Statement of Witness

Queensland Floods Commission of Inquiry

Re: Objection to Planning Application OW 6291/2009 & MCU -6293/2009
Address: North & WM Hughes St, North Ipswich
Description:
Applicant: Leda Design and Construction (Qld) Pty Ltd
RPD: Part of Lot 36 on SP175172

**RIVERLINK CENTRAL FLOOD STUDY
48 WM HUGHES STREET, NORTH IPSWICH
RESPONSE TO ADJOINING PROPERTY OWNER**

Figure 1 Locality Plan

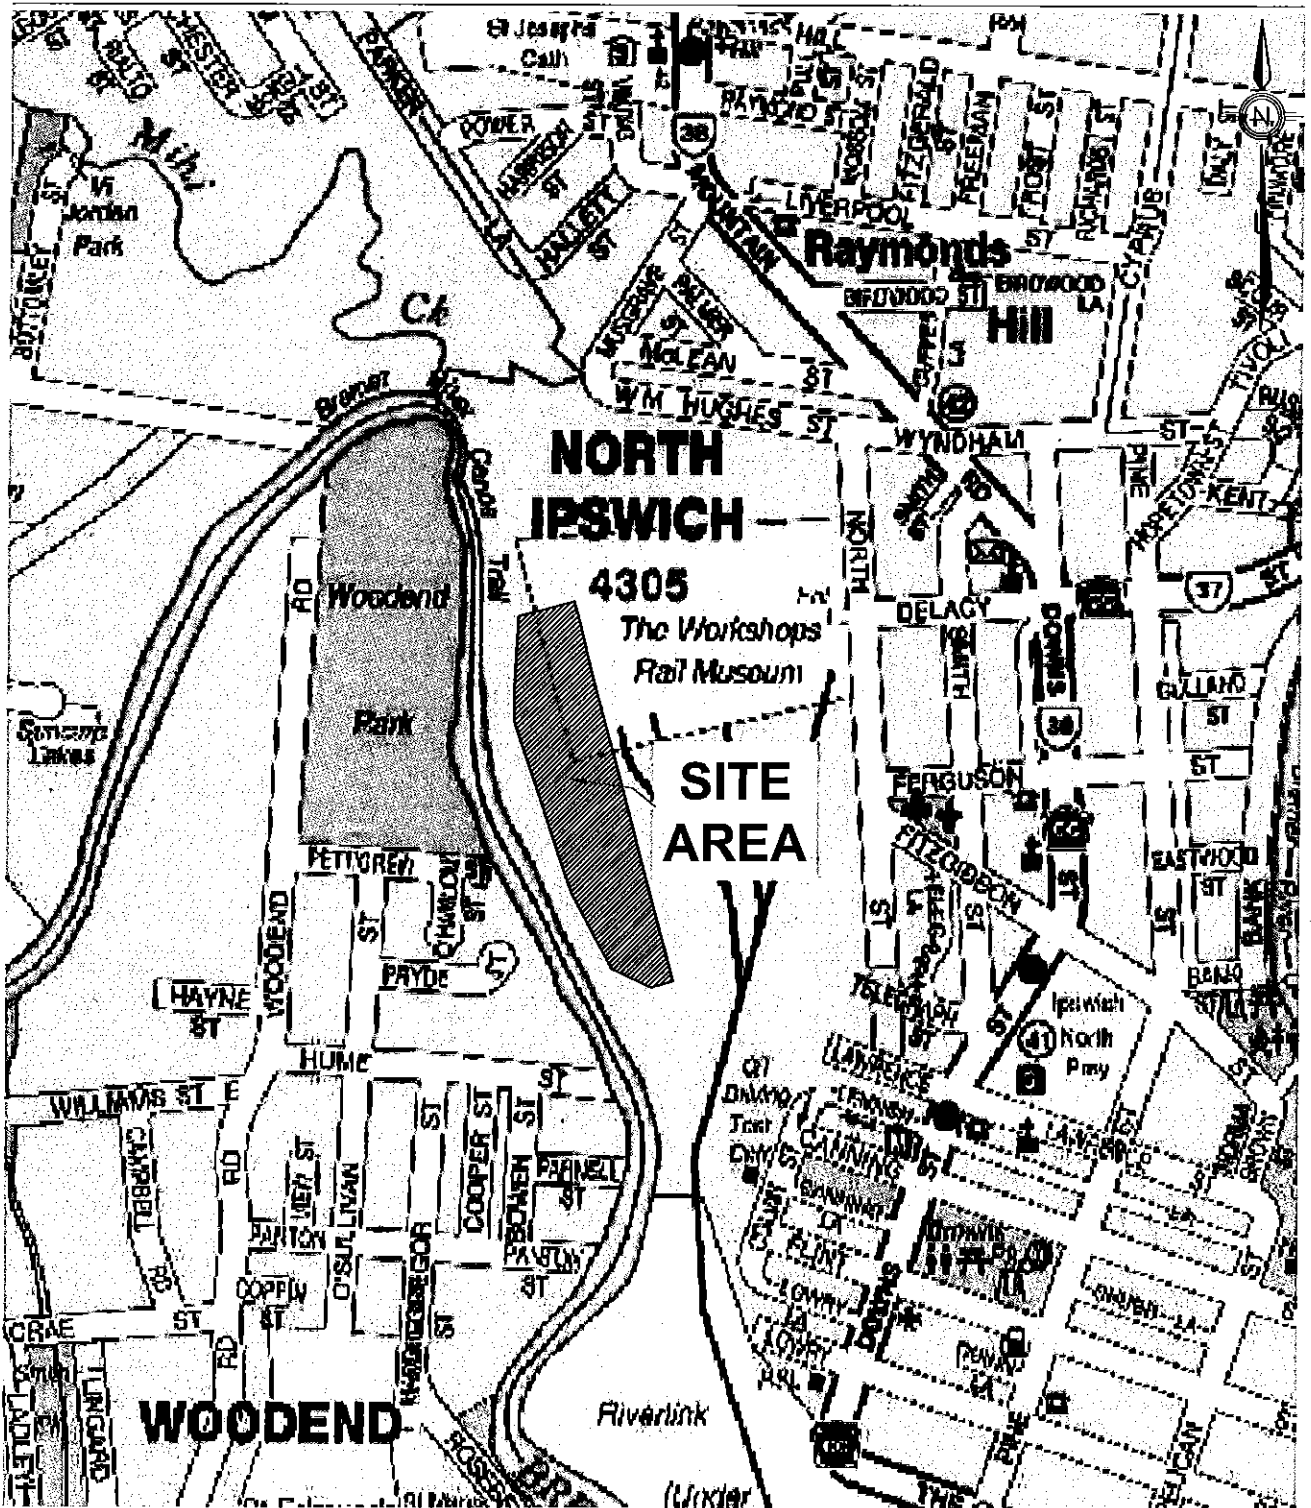
It is proposed to construct some units along the Bremer River as part of the Riverlinks development. The location of the proposed development is shown in Figure 1. As the proposed development is located within the existing extent of flood inundation of the Bremer River, compensatory excavation was required to ensure that the development did not impact on peak flood levels for neighbouring properties.

The results of MIKE11 show that the Riverlinks development, including the proposed units does not increase the flood levels for neighbouring properties. In the proposed location of the units there is generally a decrease in peak water levels of up to 92mm.

The platform level proposed for the units is 19.50m AHD. The 100 year flood level (from the 50 year Brisbane River flood event) is 18.30m AHD in the area of development. This will provide the proposed units with 1200mm of freeboard, which is more than sufficient for habitable floor levels. Section 11.4.7 of the Ipswich Planning Scheme specifies 250mm of freeboard be provided above the 100 year ARI flood level.

PROPOSED DEVELOPMENT AND MIKE11 CROSS SECTIONS

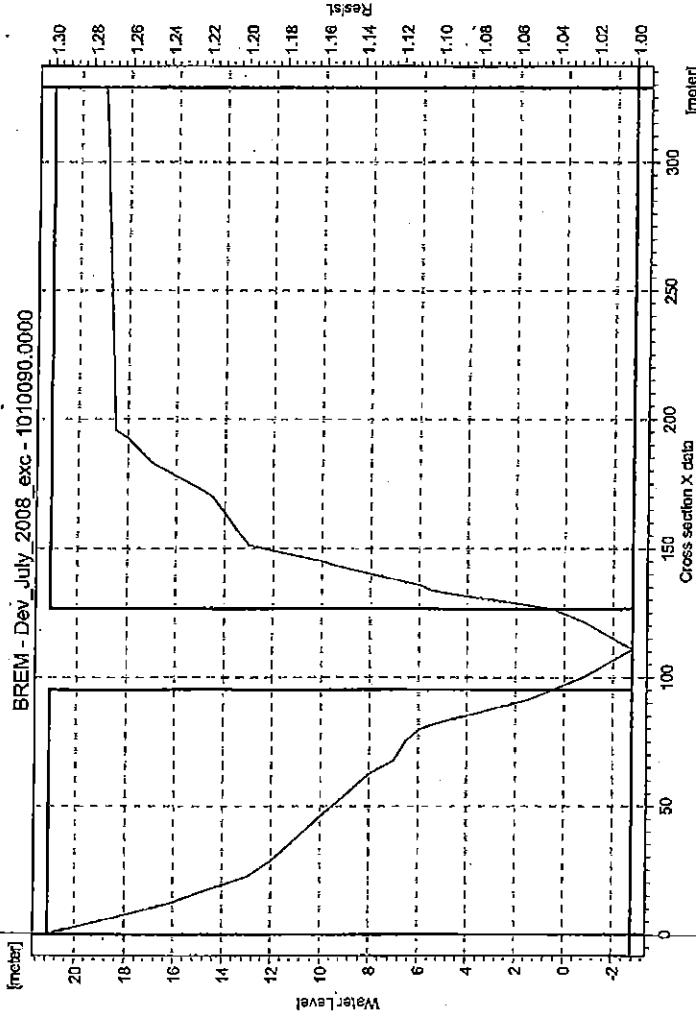
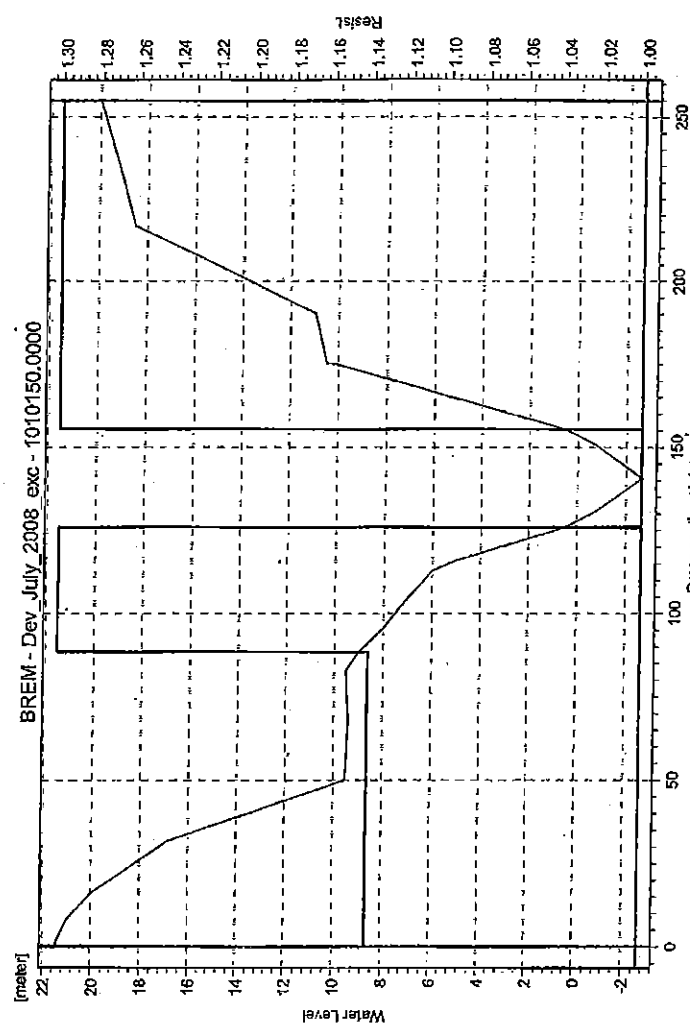
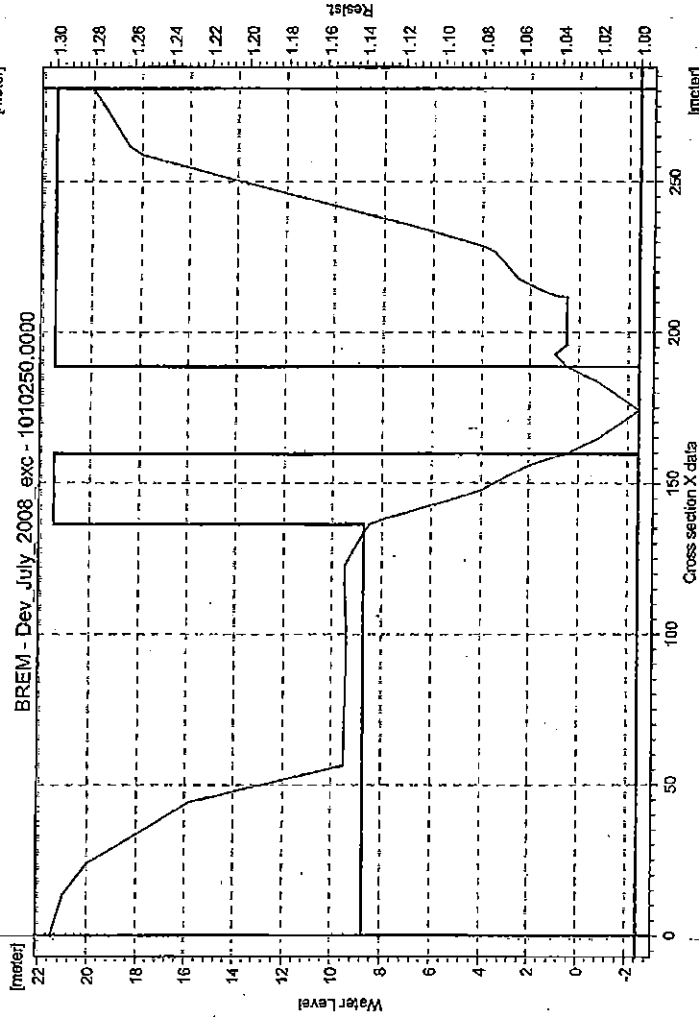
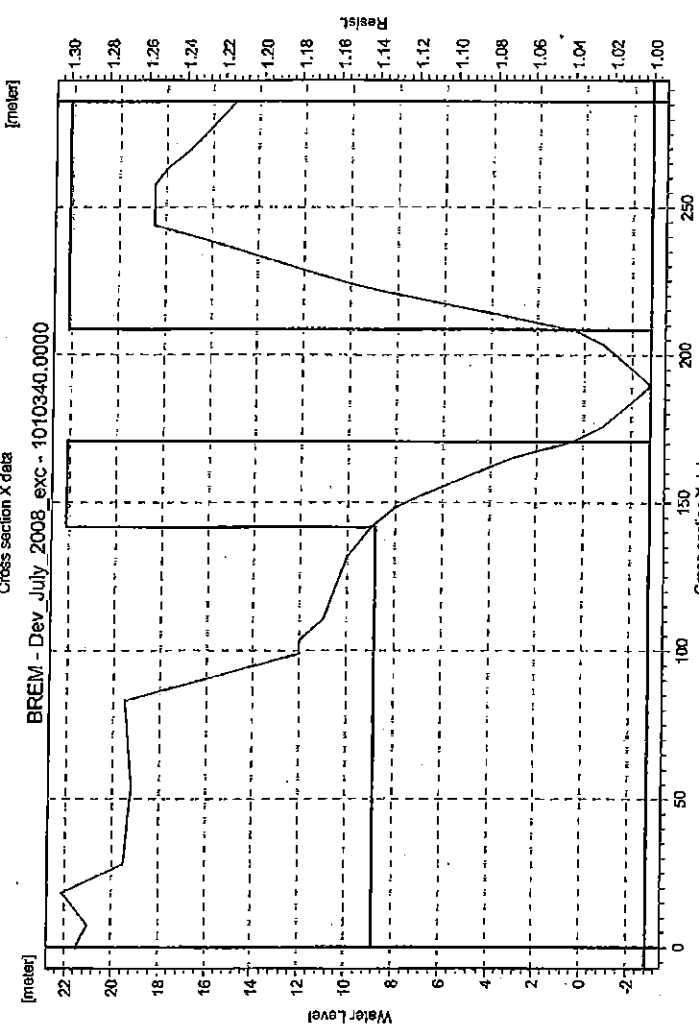
The extent of filling and excavation for the proposed development are shown in Figure 2.

2. The Flood Study is based on modelling a mismatch of data - recent contour maps (2008) and historical flood level and velocity data. The bank profile on the site has changed significantly since 1974. If there has been considerable reprofiling of the entire river bank on Lot 54 and this has not been taken into account, then you would get the same result as the Cardno Report - ie, a relocation of existing fill results in little net change between 'existing' and 'developed' cases in a flood event. The modelling does not take into account the significant narrowing of the stream profile since the 1974 flood. The modelling needs to be redone using actual 1974 river bank profiles in order to assess the effect of proposed development profile with a 50 and 100 year ARI event.

3. (i) The instability of the proposed Site Area referred to in the Flood Study is of great concern. For example, the planned earthworks to build a 19.5m platform requires up to eight meter high fill to be contained with a 1 in 2 reinforced batter. And this is on top of a substrate of railway fill (fly ash, etc) and loose sandy loams.

As noted in response to the first query, the Cardno flood study was based on the Mike-11 hydraulic model established for the Ipswich Rivers Flood Study by consultants Sinclair Knight Merz in 2000 for Ipswich City Council. The model and the report produced by the consultants has been adopted by Council and is used to provide calculated flood levels in response to flood search applications. The model therefore represents the base case against which the impact of proposed development is assessed.

In the case of the flood study, a section of the original Council model was provided to Cardno by Council. To provide additional detail in the area being considered, additional cross-sections were added to the existing case model. The channel widths for the new cross-sections were comparable to the channel widths used in the 2000 flood study (which were surveyed in 1995).

Local Flood peak at least 19.5RL

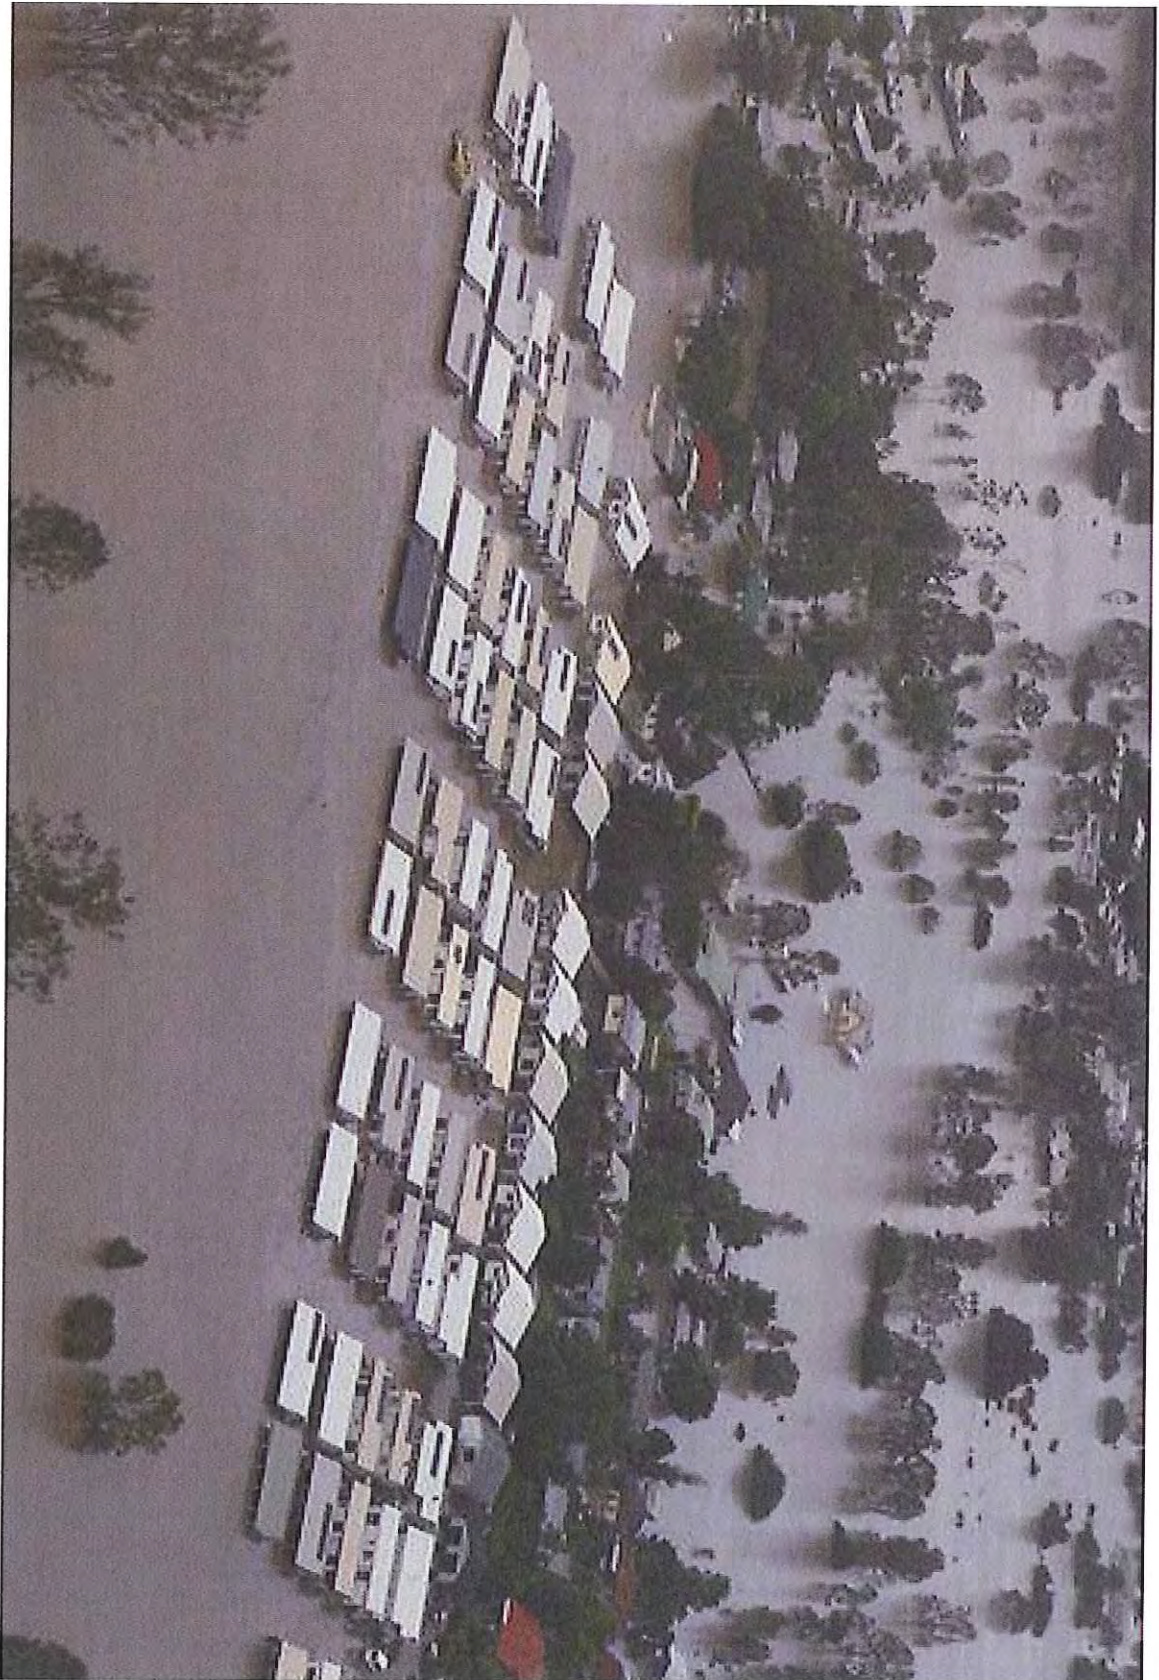
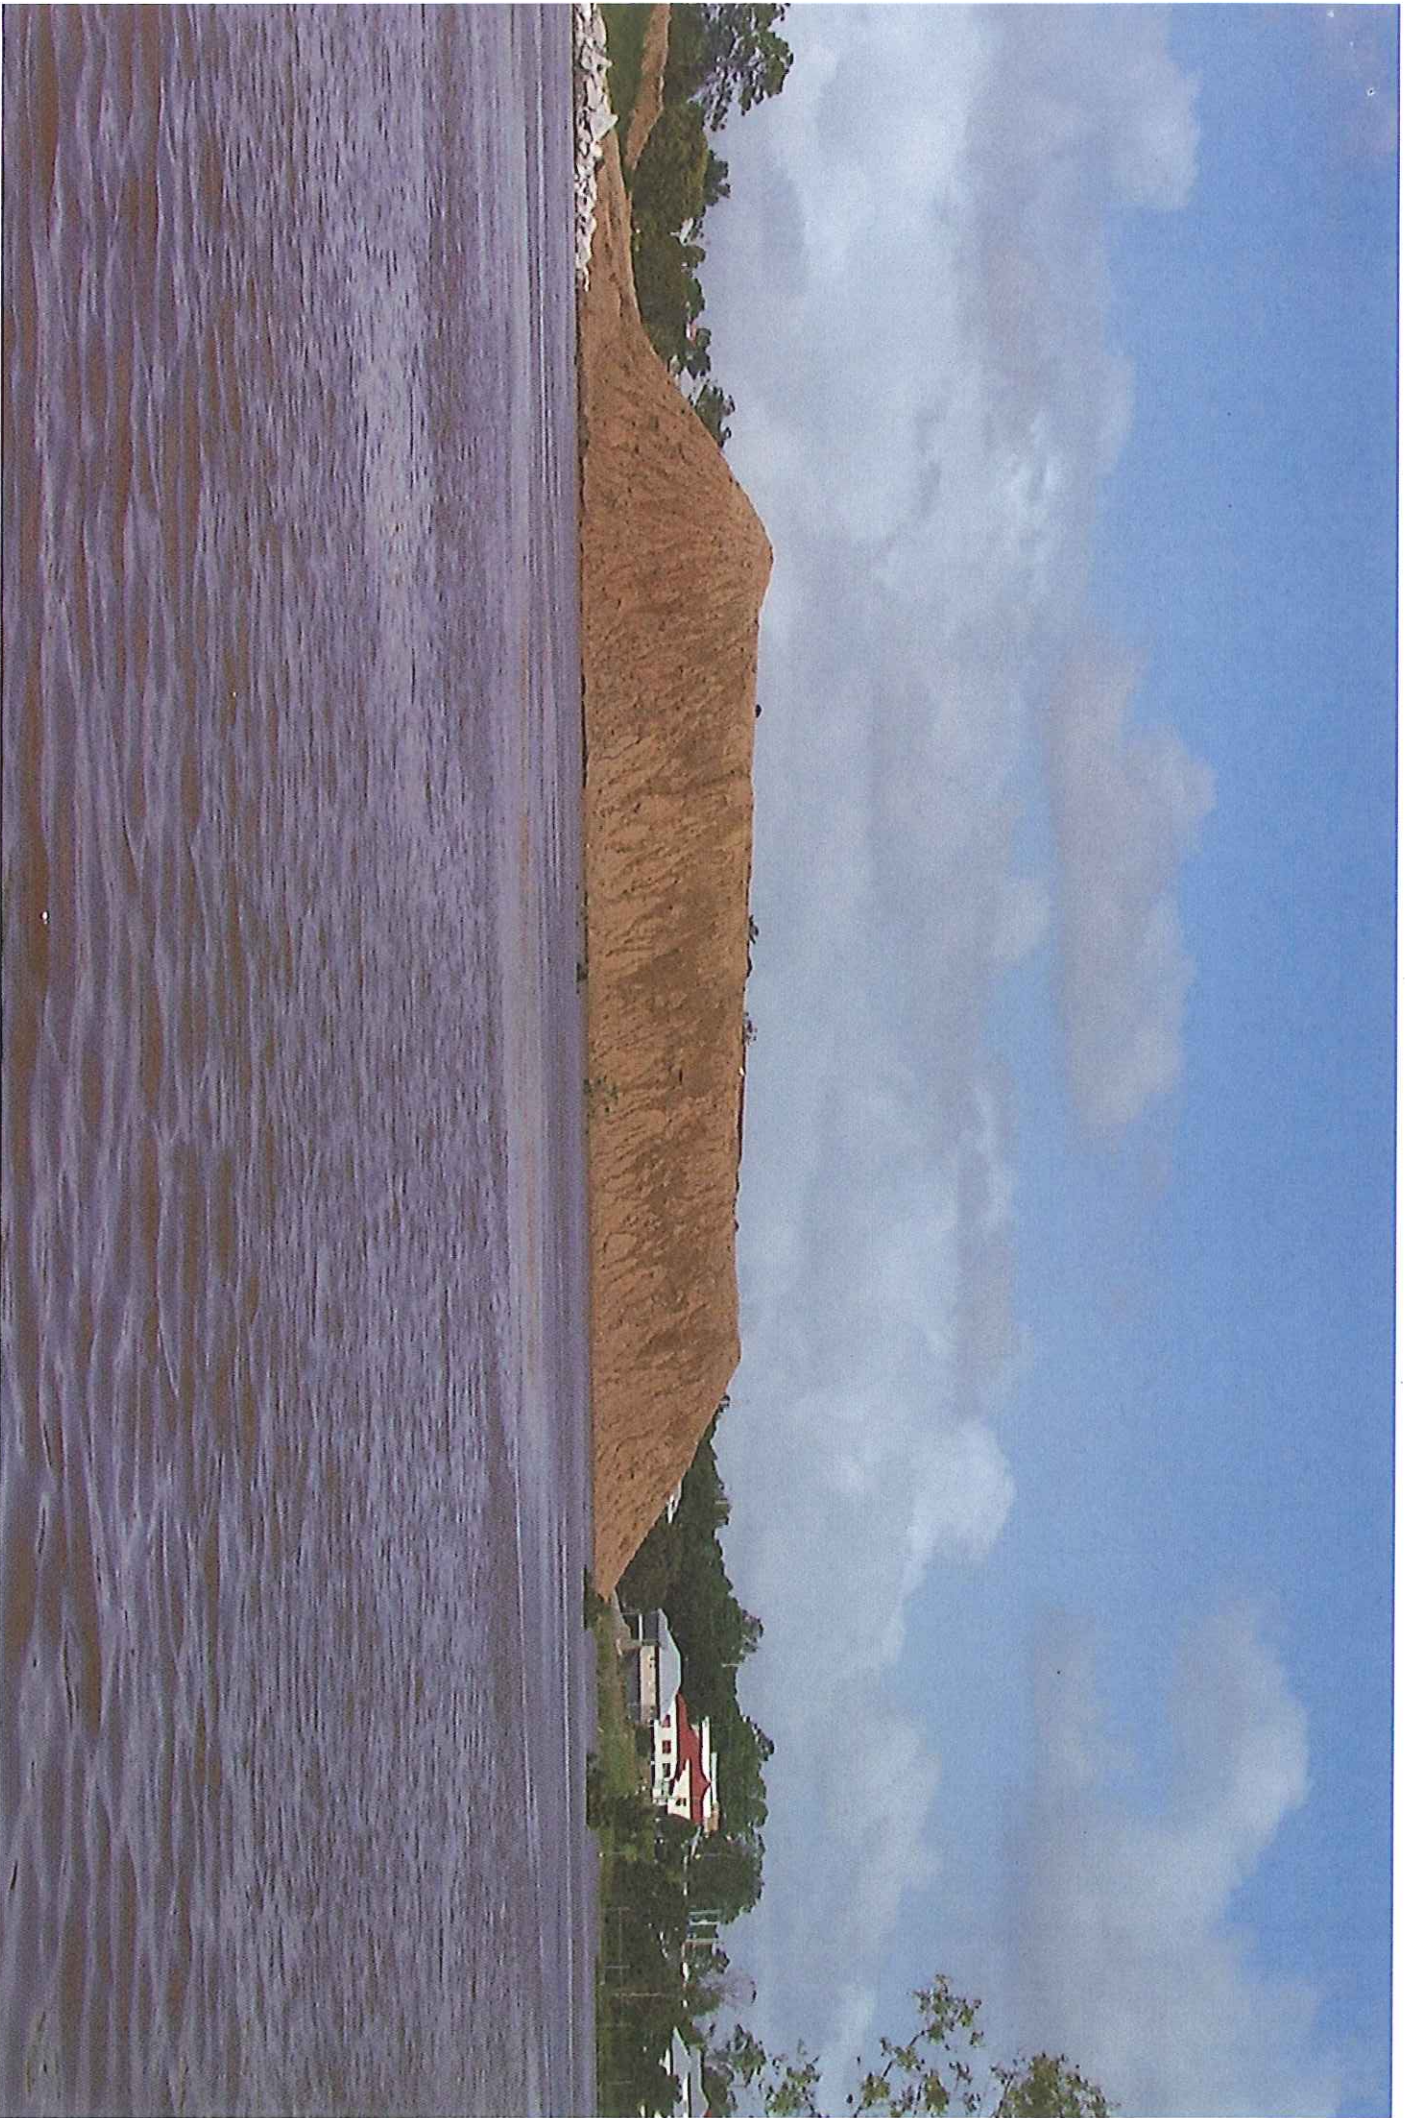
Attempted cosmetics after minor flood erosion

Floodwaters scouring contaminated fill
